**STATE OF CONNECTICUT
CONNECTICUT SITING COUNCIL**

KCE CT 9, LLC petition for a declaratory ruling, pursuant to Connecticut General Statutes §4-176 and §16-50k, for the proposed construction, maintenance and operation of a 5.0-megawatt AC battery energy storage facility located at 2 Ella T. Grasso Turnpike, Windsor Locks, Connecticut and associated electrical interconnection.	Petition No. 1579
	August 8, 2023

Petitioner KCE CT 9, LLC (“KCE”) hereby submits the following responses to the Interrogatories that were directed to KCE by the Connecticut Siting Council (“CSC” or “Council”) on July 18, 2023.

DRAWN BY: D. KENWORTHY	PROJ NO.: 22-F3
CHECKED BY: K. NICKERSON	FIGURE 4
MONTH: JULY	
YEAR: 2023

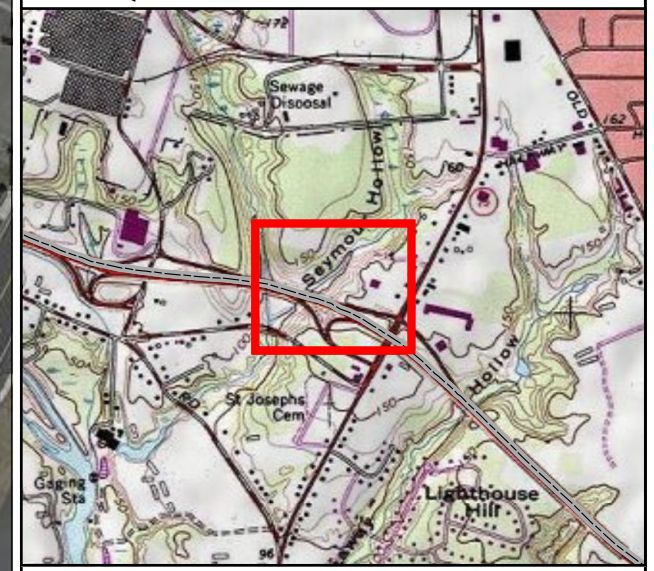
7. **Submit a map clearly depicting the boundaries of the battery energy storage facility site and the boundaries of the host parcel(s). Under Regulations of Connecticut State Agencies (RCSA) §16-50j-2a(29), “Site” means a contiguous parcel of property with specified boundaries, including, but not limited to, the leased area, right-of-way, access and easements on which a facility and associated equipment is located, shall be located or is proposed to be located.**

The Revised Figure 4, attached hereto as **Exhibit A**, includes the Host Parcel and project components, and provides the information being sought in this Interrogatory.

Not Approved for Construction
Drawing Title: **Layout & Materials Plan**

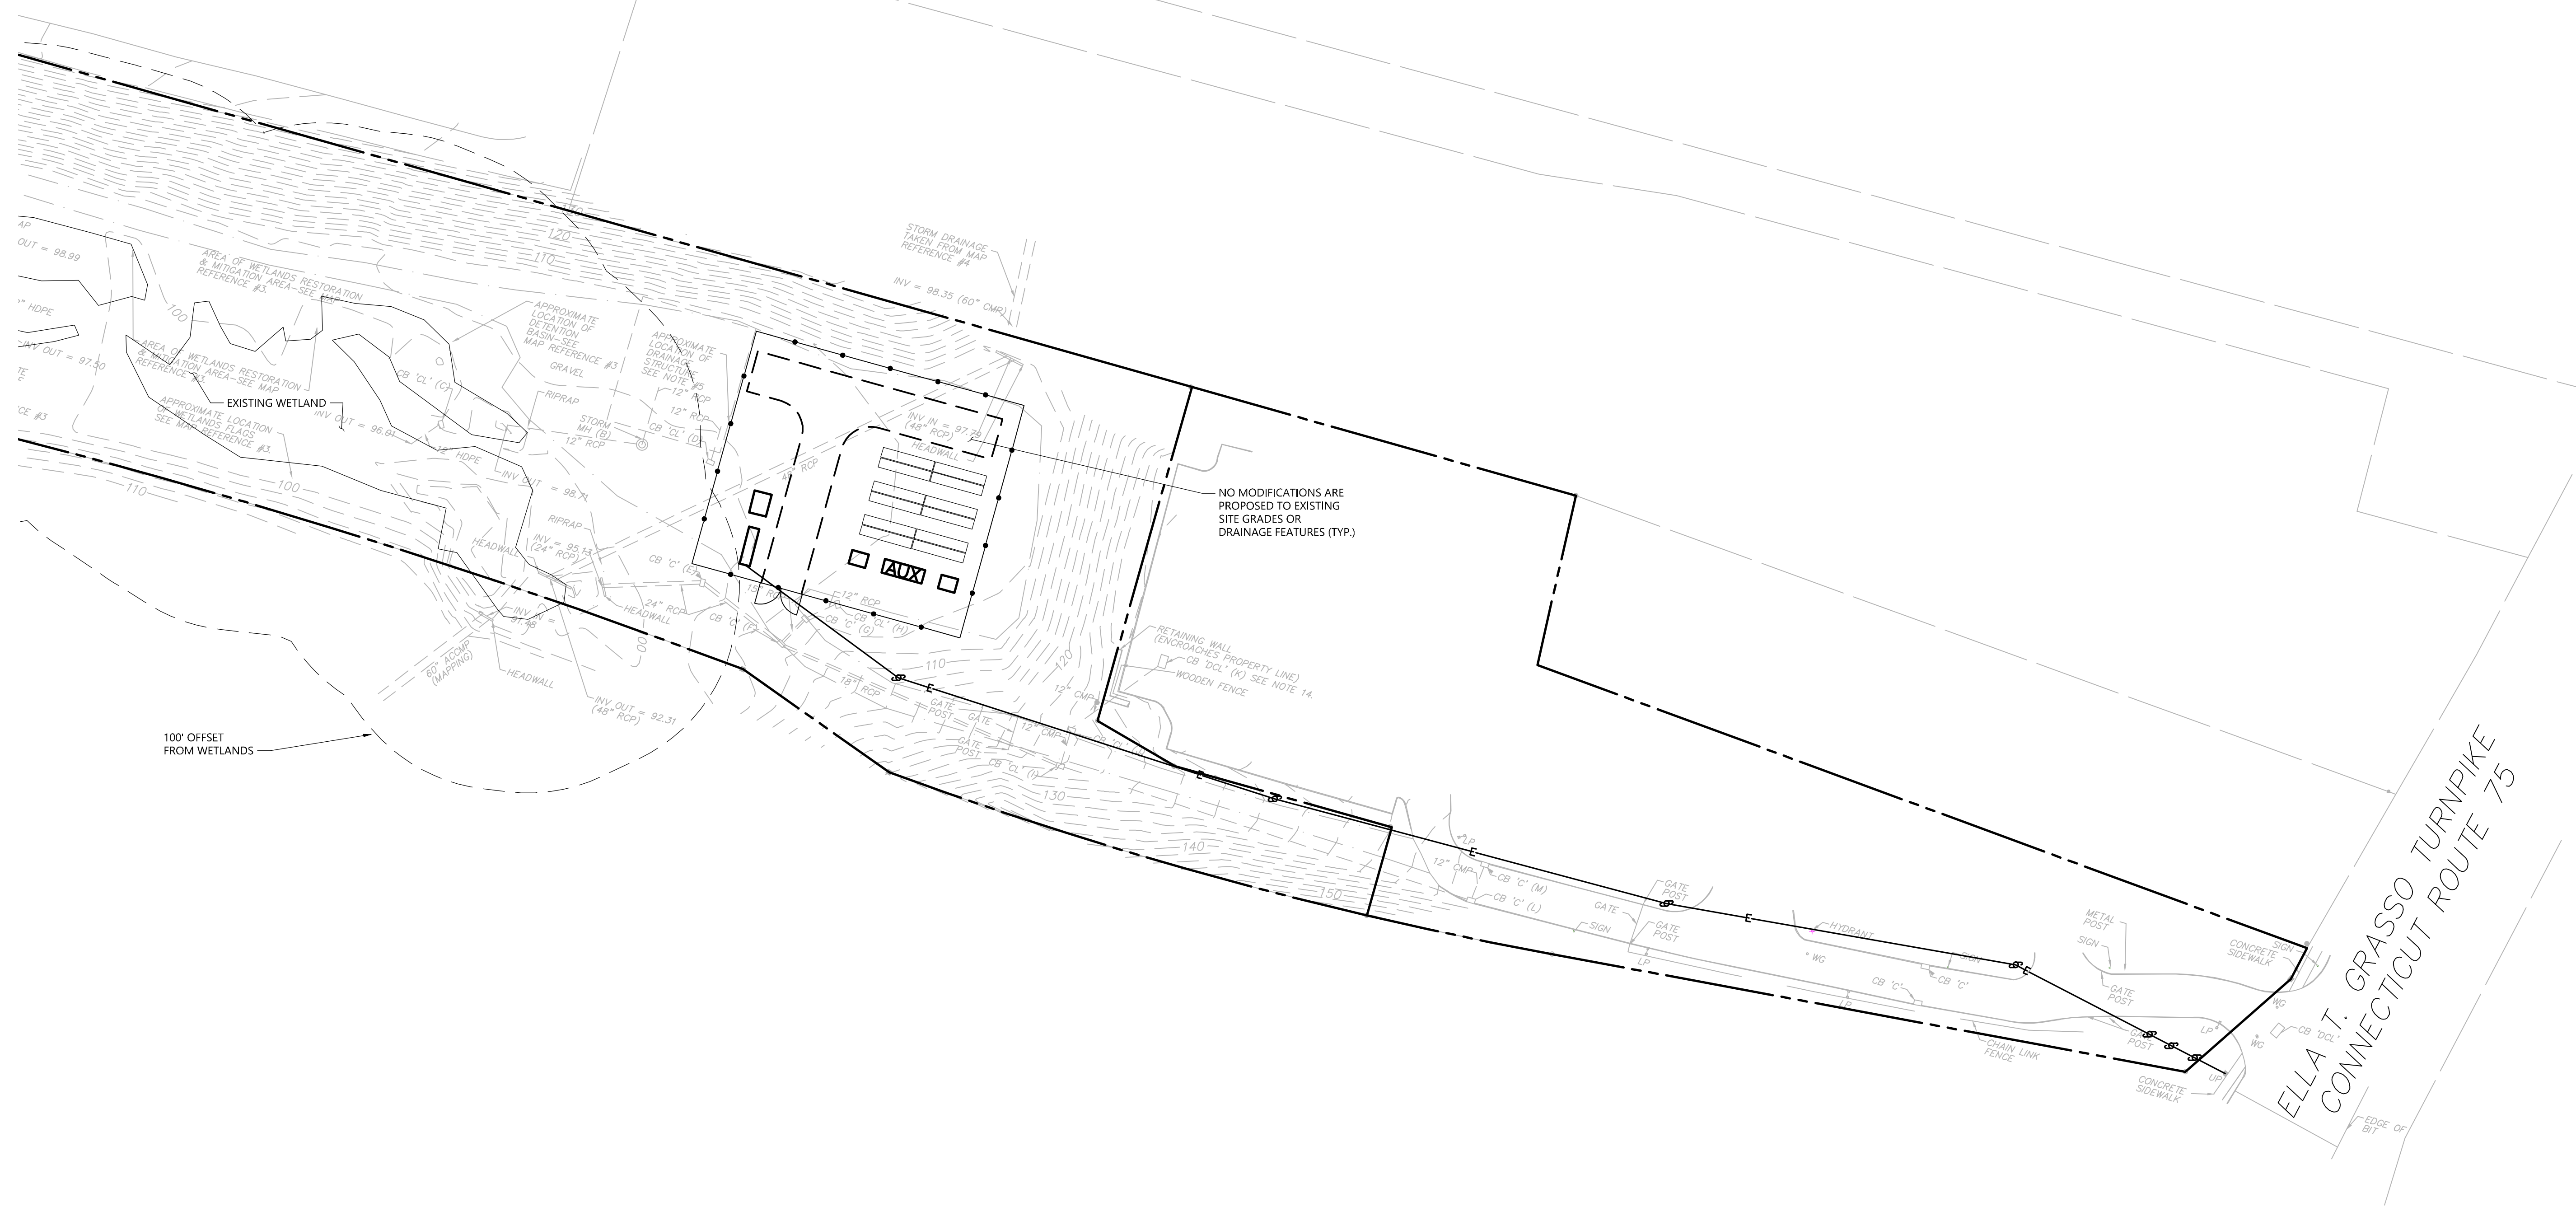
23. **Referencing Petition Tab A – Sheet C-2.0, identify where within the compound the control house would be located.**

24. **Referencing Petition Tab A – Sheet C-2.0, list the equipment that would be installed on each equipment pad.**

KCE currently intends to locate the control house at the southwestern corner of the project facility. Site Plan Sheet C 2.0 has been revised to depict this (attached hereto as **Exhibit C**).

Site Plan Sheet C 2.0 (attached hereto as **Exhibit C**) has been revised to depict the equipment currently expected to be installed on each equipment pad.

Barton & Loguidice logo and contact information. Project details: ALTA/NSPS LAND TITLE SURVEY, PREPARED FOR KEY CAPTURE ENERGY, LLC, KCE CT9 WINDSOR LOCKS, 2 ELLA T. GRASSO TPKE, WINDSOR LOCKS, CT. Project number: 4428-001-005, Date: 7/18/22, Sheet: 1 of 1.

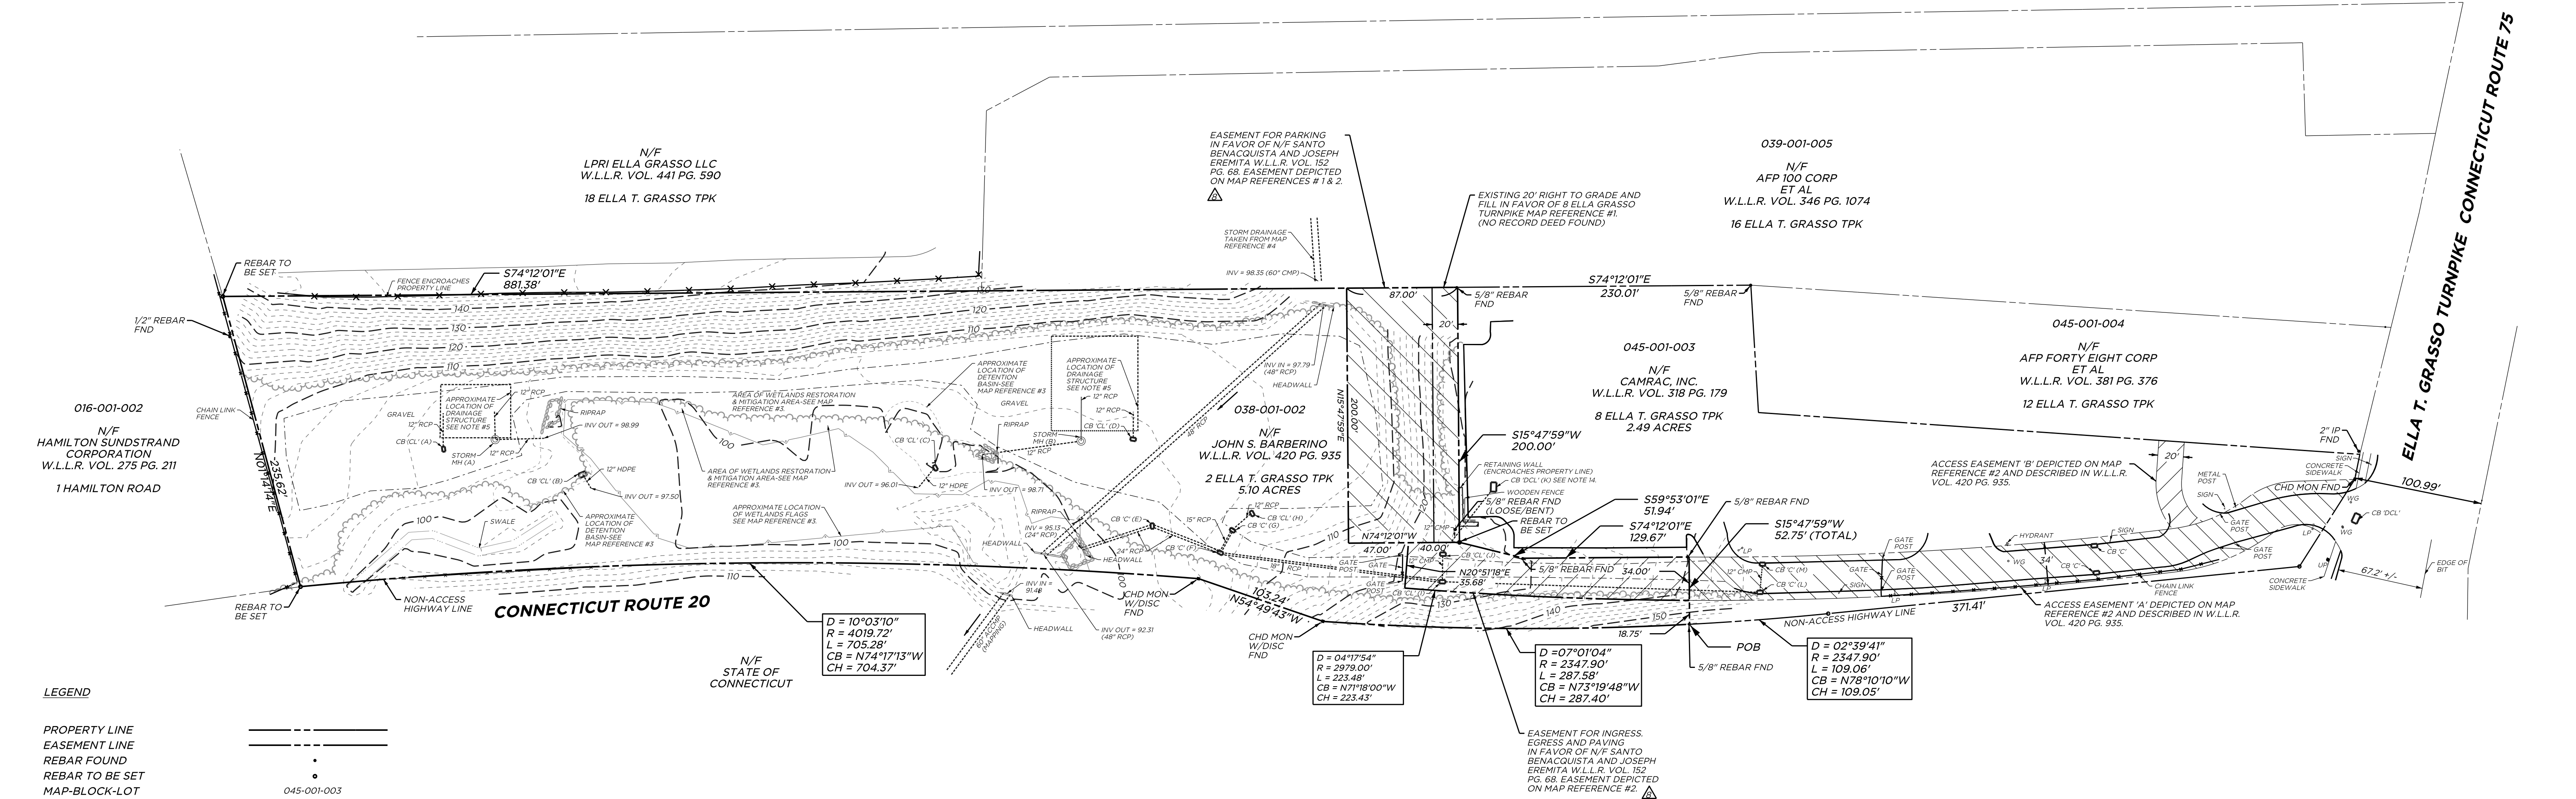
9. **Referencing Figure 3, ALTA/NSPS Land Title Survey:**

- a. **Would KCE use the existing easement for access across the Camrac, Inc. property at 8 Ella Grasso Turnpike (Access Easement A) in order to reach the host parcel from Ella Grasso Turnpike?**

- b. **Would KCE use the existing 20’ right to grade and fill on the Camrac, Inc. property at 8 Ella Grasso Turnpike to develop the facility site?**

Yes, the Property at 2 Ella Grasso Turnpike has a deeded access easement in the location identified on the project plans that will be used as the project access point.

The project has been designed to have no impact on this area. No earthwork, grading, filling or construction or laydown activities will be conducted in the noted area.
